Pearmtree Hill Solar Farm

Response to Rule 17 – Request for Further Information

Document Ref: EN010157/APP/8.27

Traffic Distribution Clarification Note in Response to Rule 17 Request

Image 1: Snip of ES Volume 3, Figure 14.2 Transport Routing and the Existing Highway Network [REP2-121]

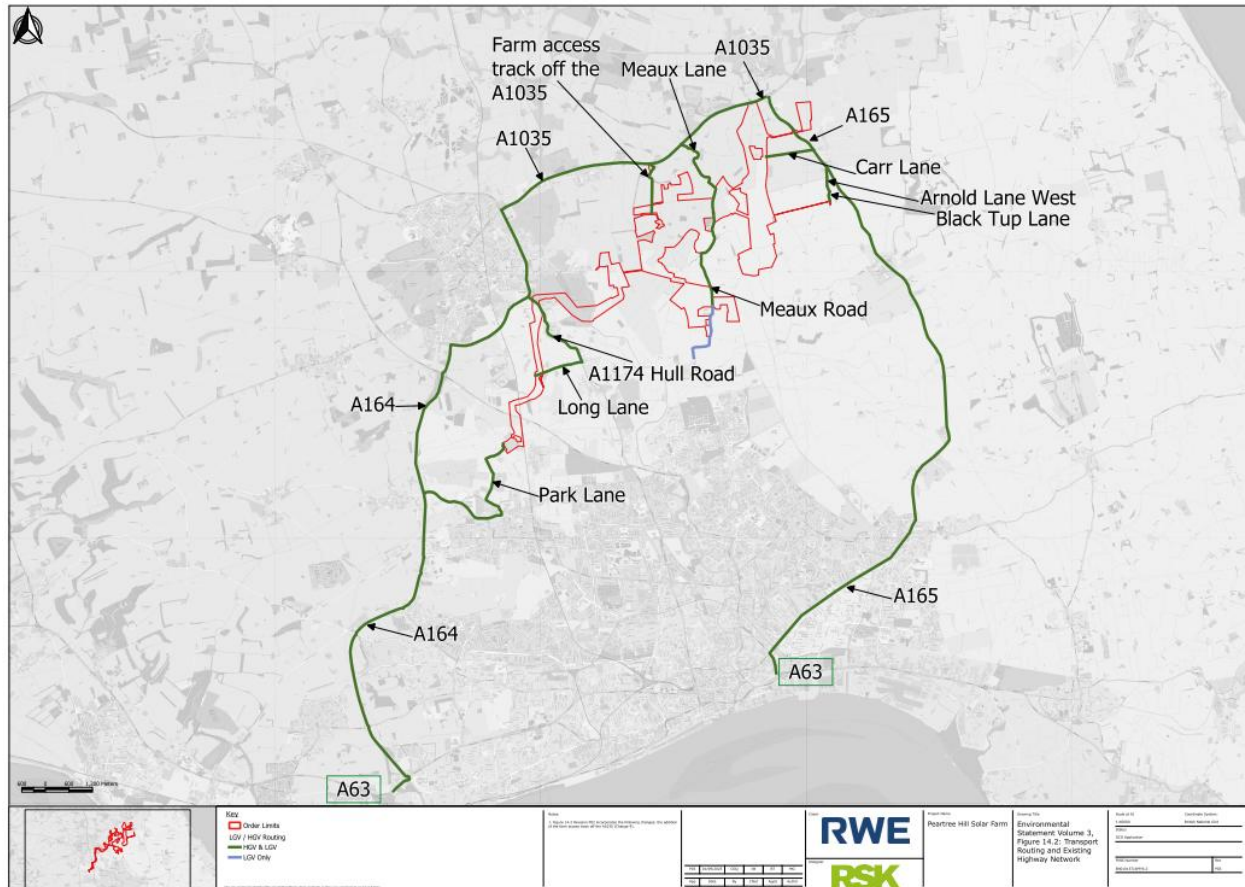
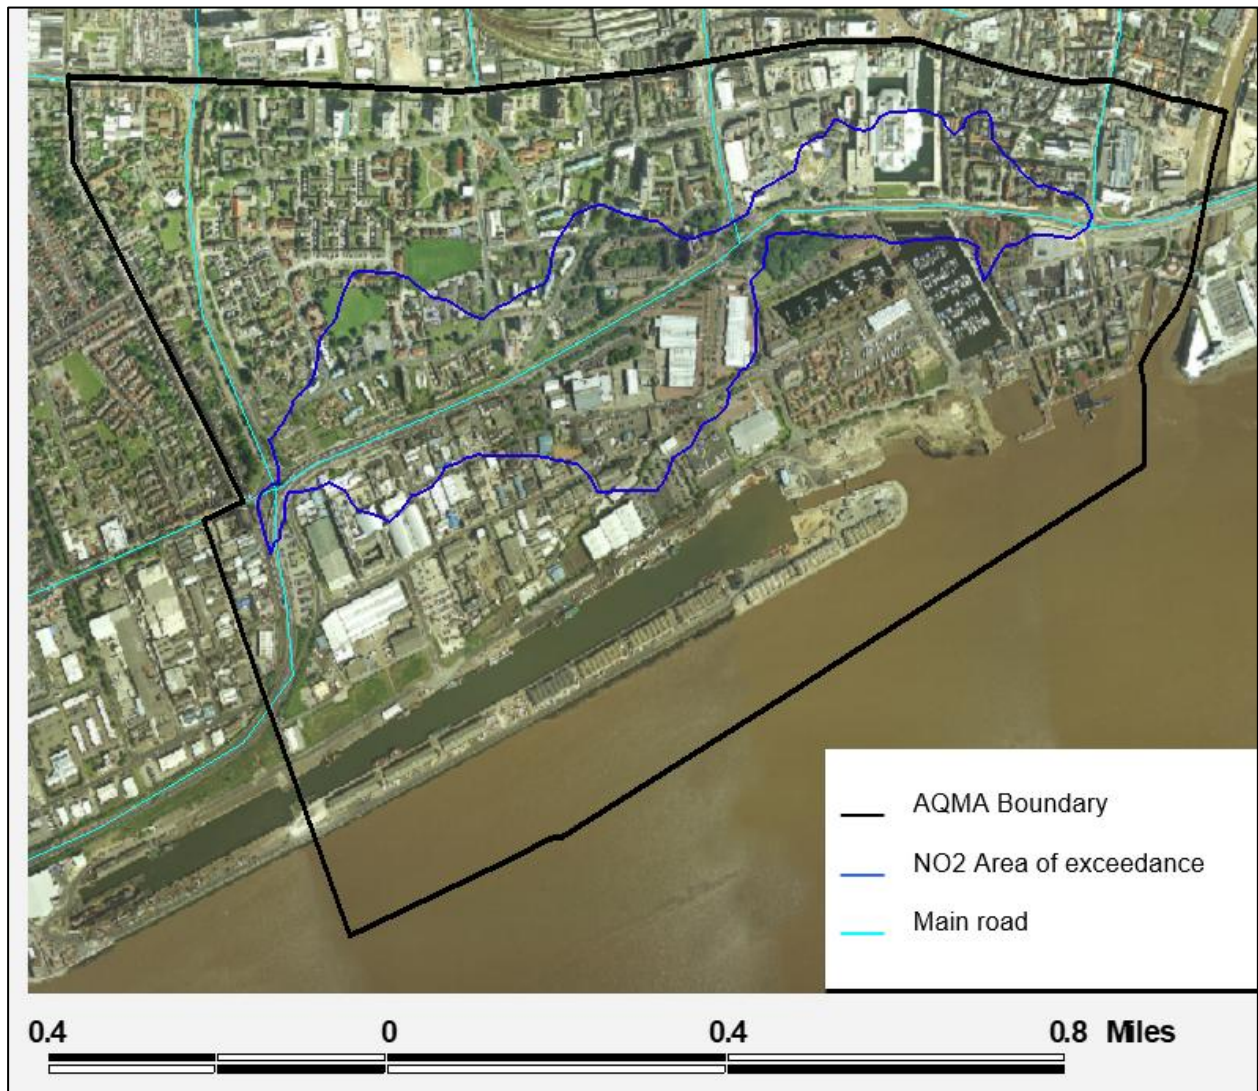
“The ExA notes the applicant’s response to ExQ3.5.1b) and c) [REP5-080]. However, some of the traffic figures (including 24, 27, 32, 34, 26, 40, 42, 44 and 48) of the Transport Assessment [REP4-025] state that “It is assumed that 50% of vehicles will travel to and from Hull Port via A1035 at Beverley and 50% via the A165.”. The ExA is therefore unclear how the applicant concludes that “[...] traffic routing to and from the Site along sections of route A63 will not pass through Hull AQMA 1.”. The ExA therefore requests:

a) Further information around anticipated annual average daily traffic (AADT) levels on the A63 through Hull’s air quality management area (AQMA) and, if this is likely to exceed the relevant criteria, further justification for a lack of an air quality assessment in this regard; and

1.1.3 Whilst the numbers stated are correct, the text on the traffic figures was a wording inconsistency that could be interpreted as implying all HGV and LGV construction trips travel to and from the Port of Hull, which would not be the case. The correct wording for the purposes of all the assessments in **ES Volume 4, Appendix 14.1: Transport Assessment [REP4-026]** and **ES Volume 2, Chapter 14: Transport and Access [REP5-018]** is set out in Table 14-4 of **ES Volume 2, Chapter 14: Transport and Access [REP5-018]** in relation to the construction assumption for ‘Distribution of Delivery LGVs and HGVs’ and reads as follows:

“For the purposes of this assessment, it has been assumed that HGVs and LGVs will access the Site either from Strategic Road Network at Hull Docks or the A1(M)/M62. For local road assessment within the study area, it has been assumed that 50% of delivery vehicles will access the Site via the A165 and 50% will access via the A1035 at Beverley.”

- 1.1.5 Based on the above assumption and the transport routing shown in Image 1, it has been assumed that construction LGVs and HGVs will either access the site via the A165 from the Port of Hull *or* along the A164 and A1035 from the wider Strategic Road Network (SRN).
- 1.1.6 It is not anticipated that construction LGVs and HGVs to/from the Port would need to pass along the A63 through the Air Quality Management Area (AQMA) declared in the city of Hull (see Image 2), as the most direct route to/from the Site is along the A165. Similarly, it is not anticipated that construction LGVs and HGVs to/from the wider SRN and motorway network (M62 and A1(M)) would need to pass along the A63 through the AQMA, as the most direct route is along the A164.
